Title: HEATING & COOLING TOWN HALL & HOTEL GROUND FLOOR

Project: HORNSEY TOWN HALL

Dwg Number: 10687-H-02-TH-0100

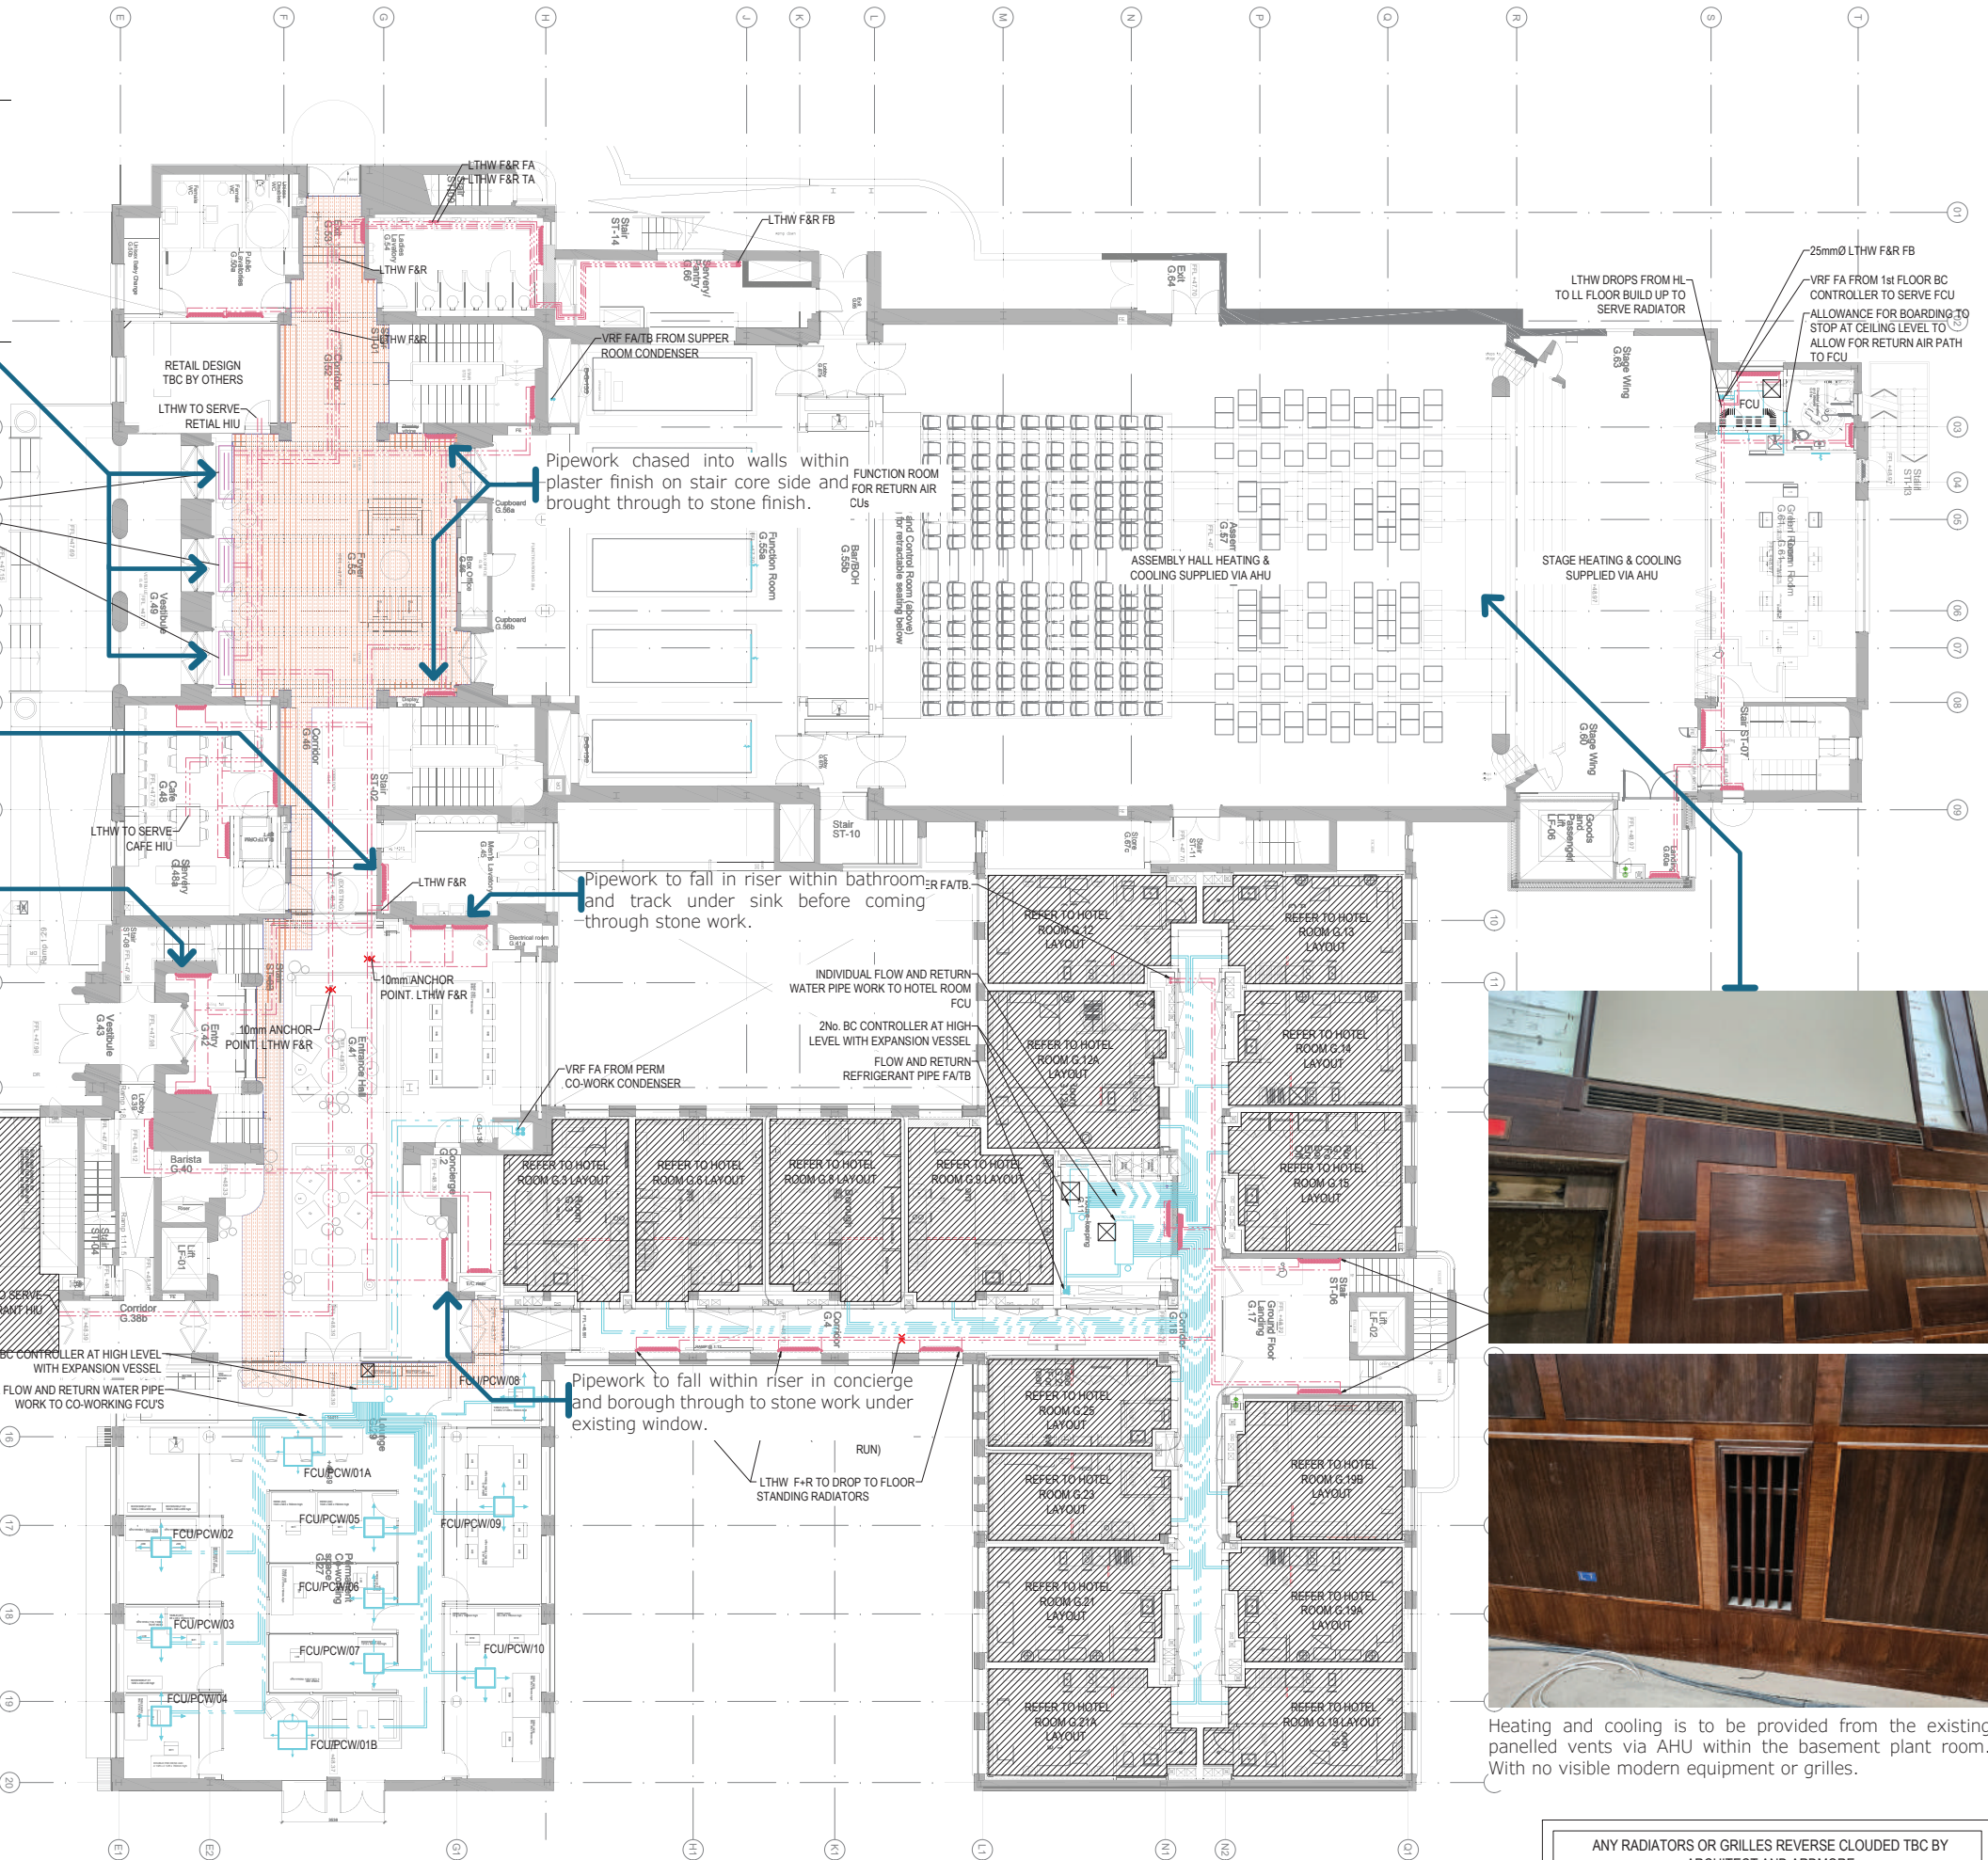
For Entrance Hall and Foyer, heating is provided via radiators matching the specifications of the radiators used across the building. As the electrical strategy the pipe routes are within the ceilings and brought down within BOH spaces. As previous page, two holes are to be core drilled into stone in exact locations for the pipes to meet the inlet and outlet valves. Removing the requirements for any face fixing of pipes on to the stone work.

Radiators fed from below - with single core drill hole below inlet and outlet valves.

Heating and cooling is to be provided from the existing panelled vents via AHU within the basement plant room. With no visible modern equipment or grilles.

ANY RADIATORS OR GRILLES REVERSE CLOUDED TBC BY
ARCHITECT AND ARDMORE
